ALASKA RAILROAD CORPORATION
327 W. Ship Creek Ave.
Anchorage, AK 99501
Phone 907-502-0007
HumphreyC@akrr.com

Addendum Number 3

ITB 23-45-210858

SECTION TRUCK SERVICE BODY

Revised 08.15.2023

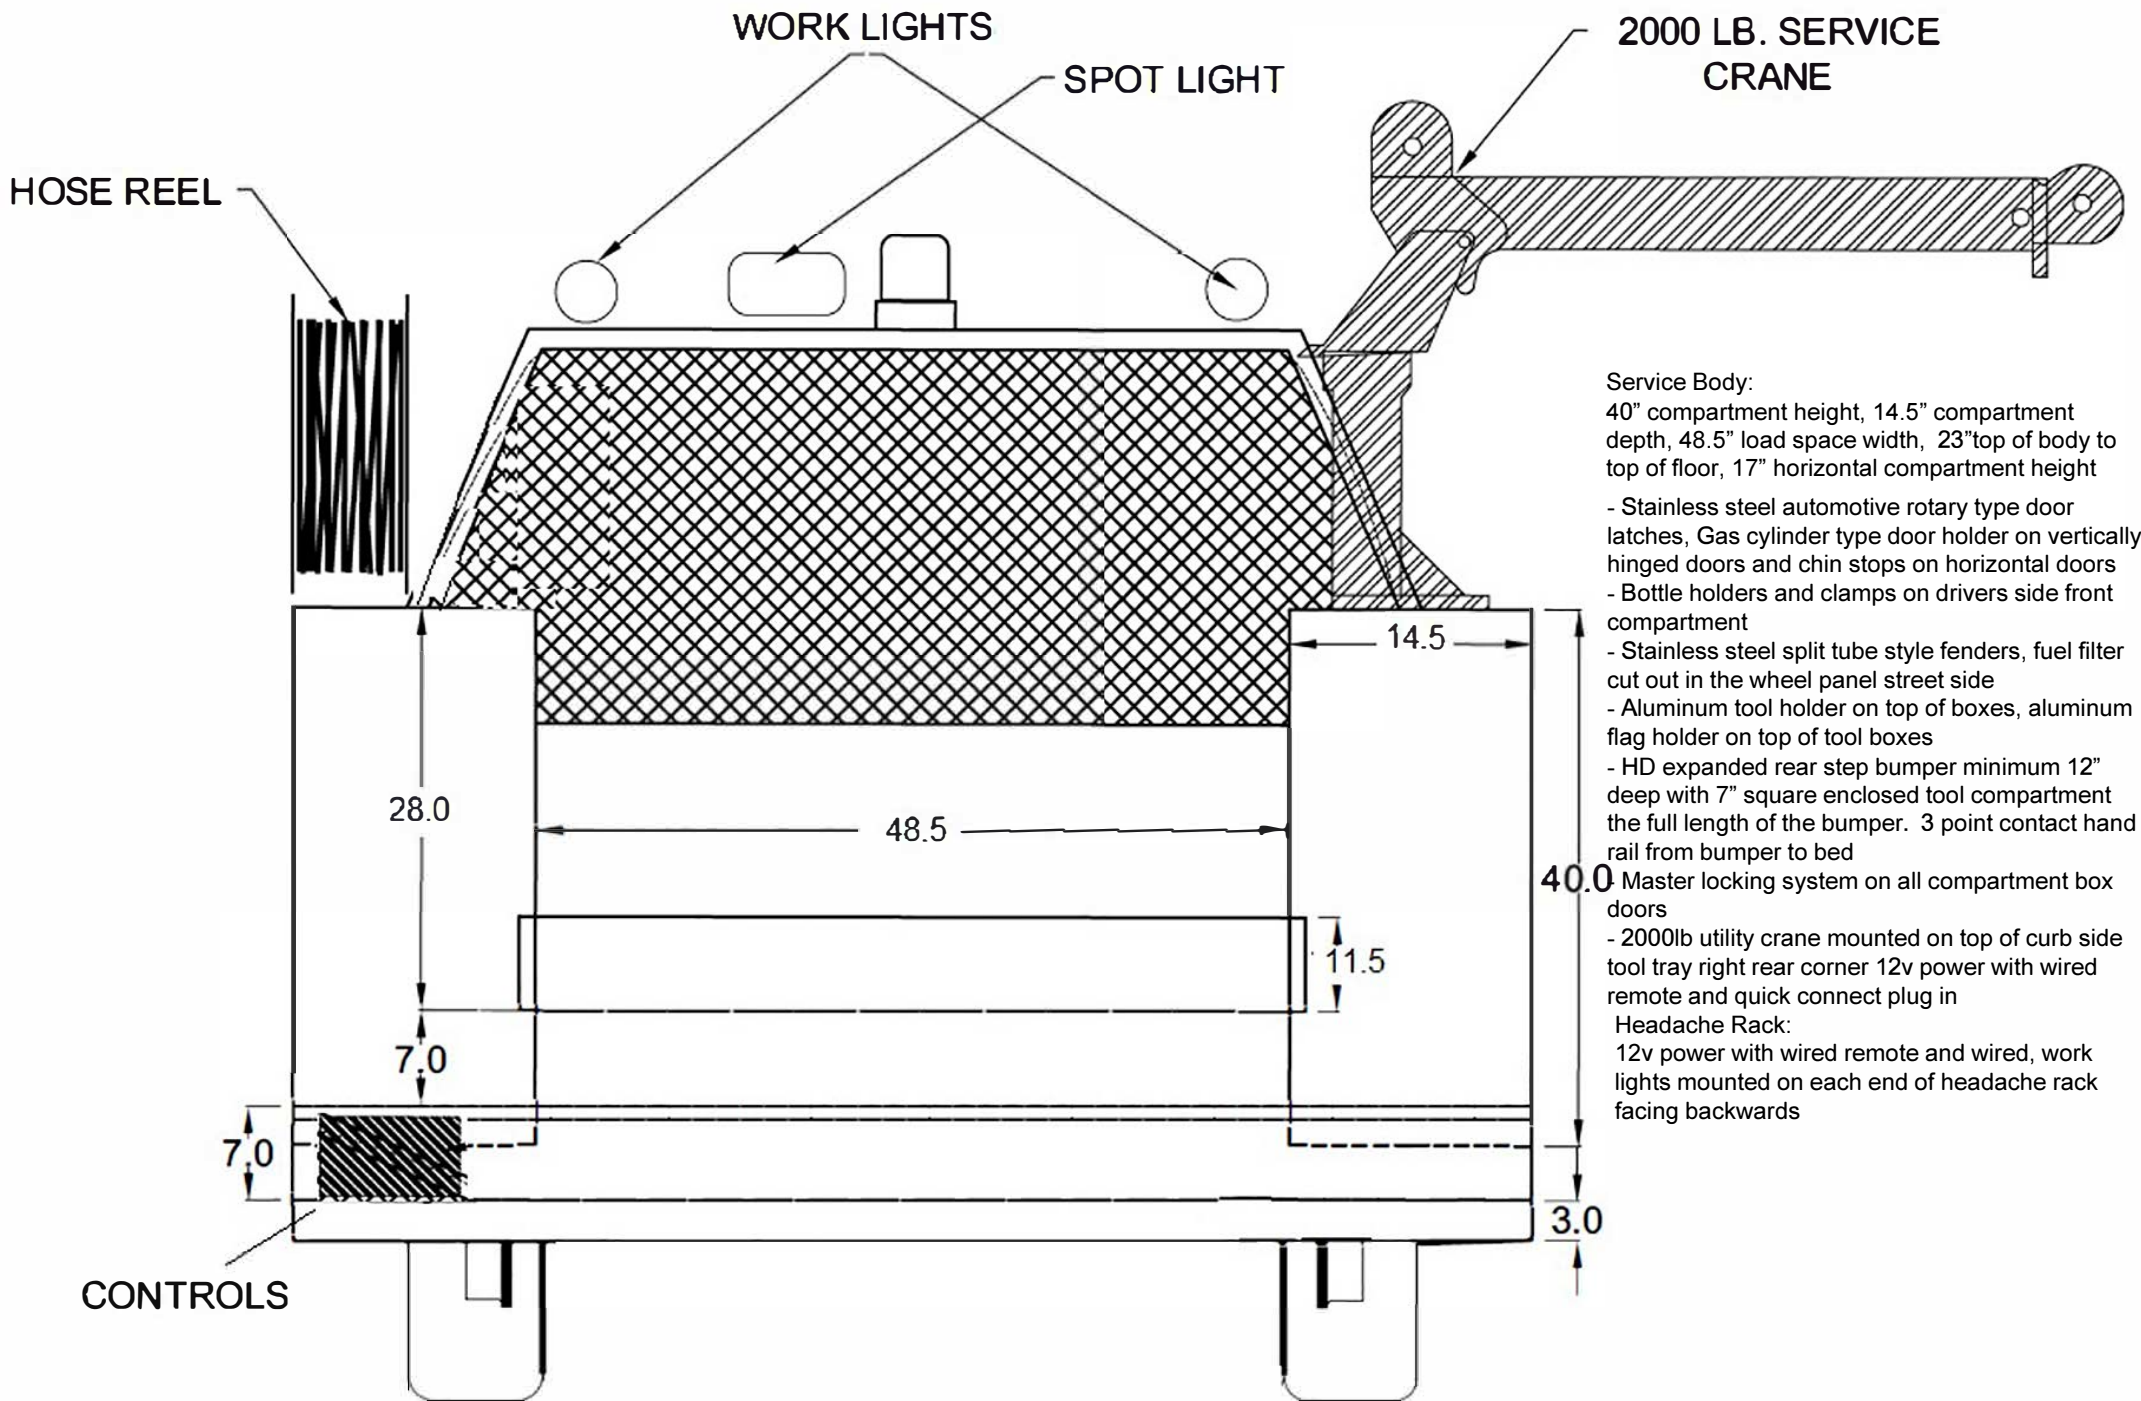
Service Body:

40" compartment height, 14.5" compartment depth, 48.5" load space width, 23" top of body to top of floor, 17" horizontal compartment height

- Stainless steel automotive rotary type door latches, Gas cylinder type door holder on vertically hinged doors and chin stops on horizontal doors
- Bottle holders and clamps on drivers side front compartment
- Stainless steel split tube style fenders, fuel filter cut out in the wheel panel street side
- Aluminum tool holder on top of boxes, aluminum flag holder on top of tool boxes
- HD expanded rear step bumper minimum 12" deep with 7" square enclosed tool compartment the full length of the bumper. 3 point contact hand rail from bumper to bed
- Master locking system on all compartment box doors
- 2000lb utility crane mounted on top of curb side tool tray right rear corner 12v power with wired remote and quick connect plug in

Headache Rack:

12v power with wired remote and wired, work lights mounted on each end of headache rack facing backwards
